Planning and Development
30 S. Nevada Ave., Suite 701
Colorado Springs, CO 80903

Final Report - Corrections Required **Application No. PDZD-26-0017**

Description : PDZ Development Plan for the Paint Mines at Reagan Ranch comprised of 102 single-family attached residential lots on 15.283 acres.

PDZ DEVELOPMENT PLAN

LP1.00

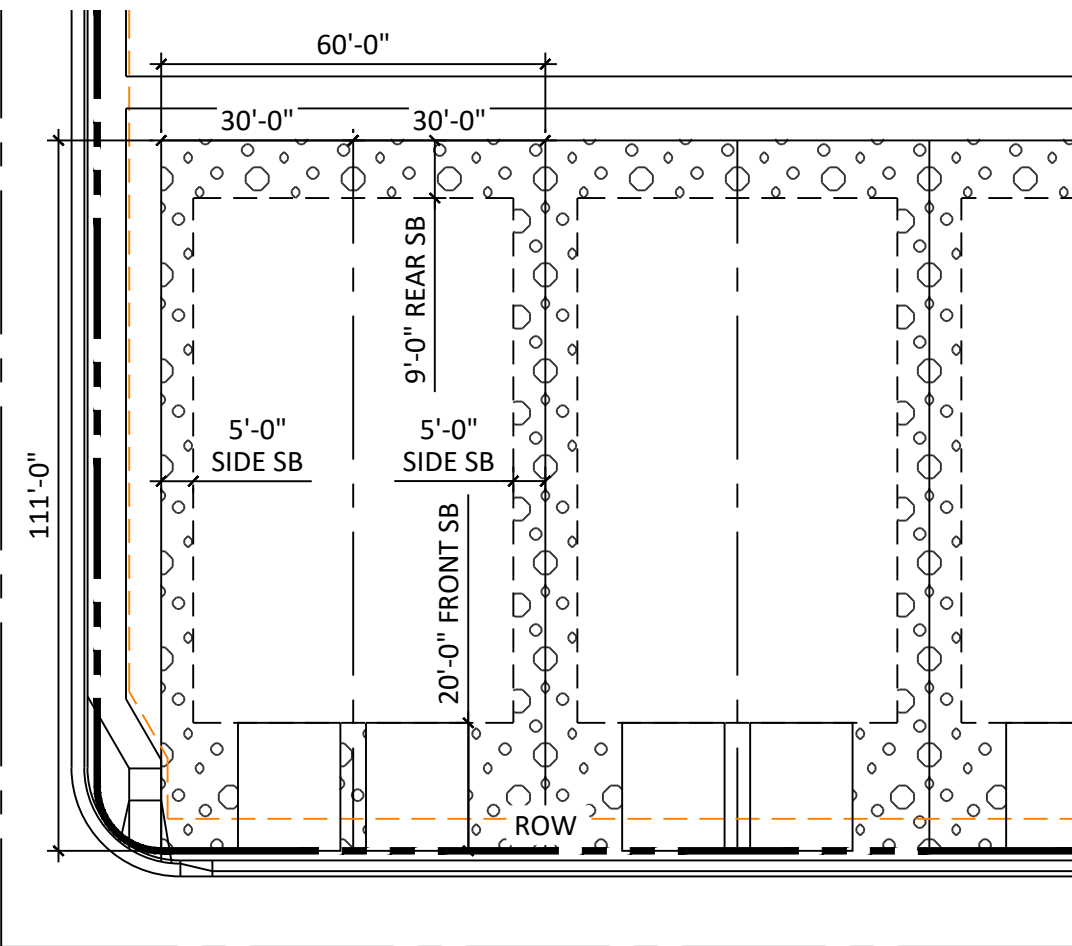
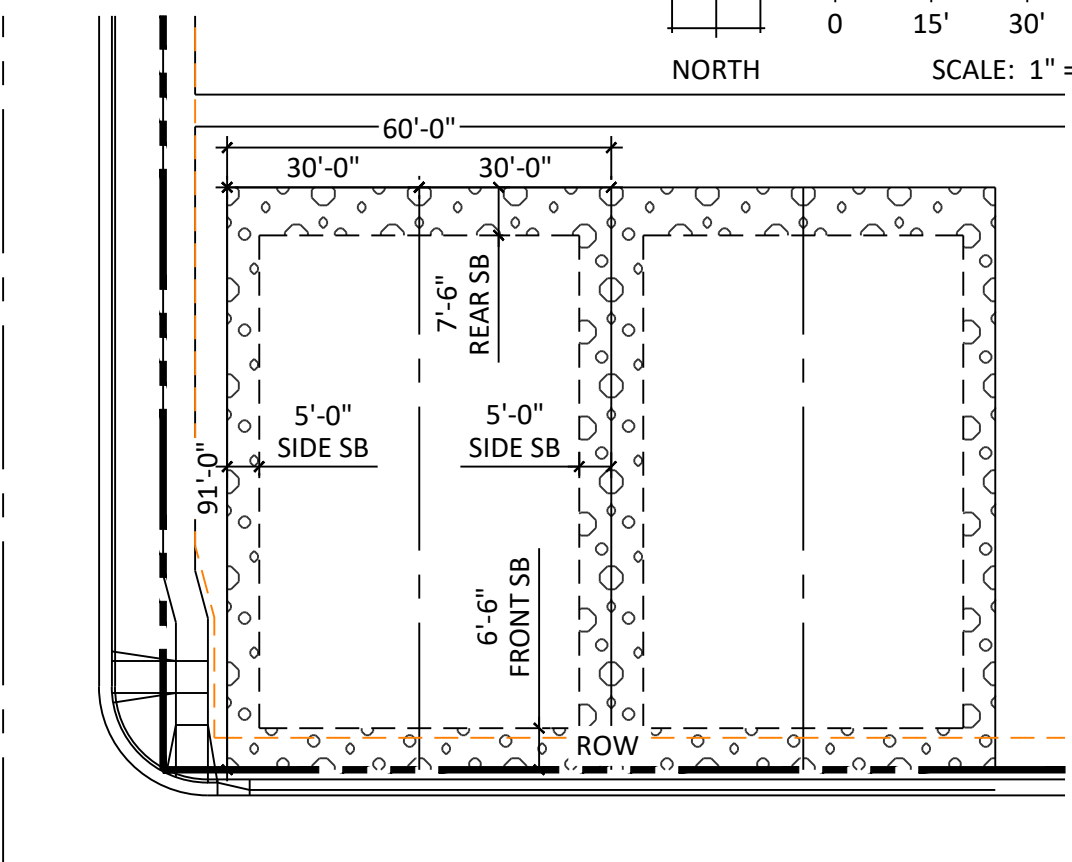
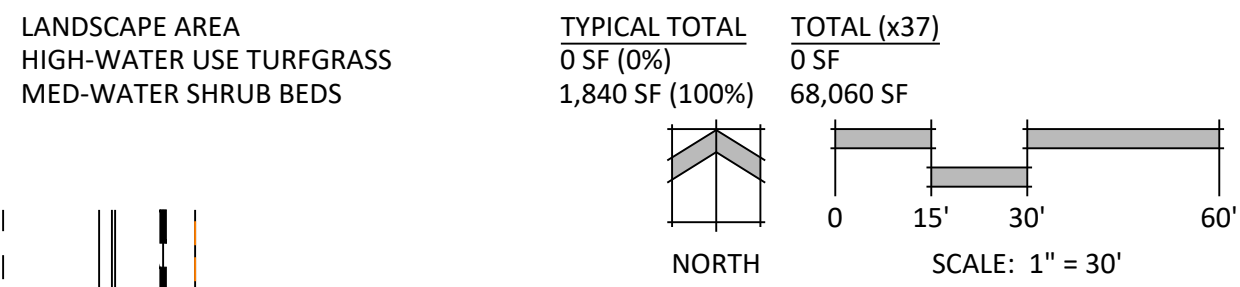
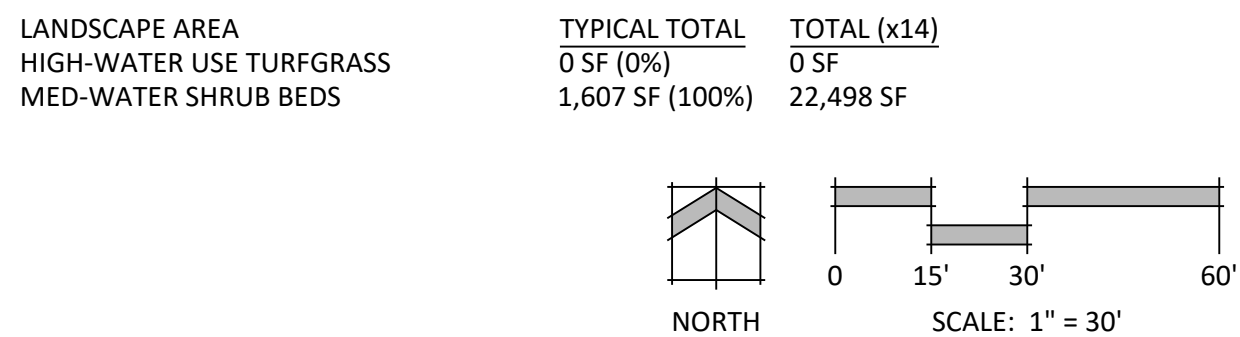
Add a note stating, "Trees shall not be planted in an easement and shall maintain a 15-foot minimum separation from water and wastewater mains, or services and a 6-foot minimum separation from electric and gas distribution lines."
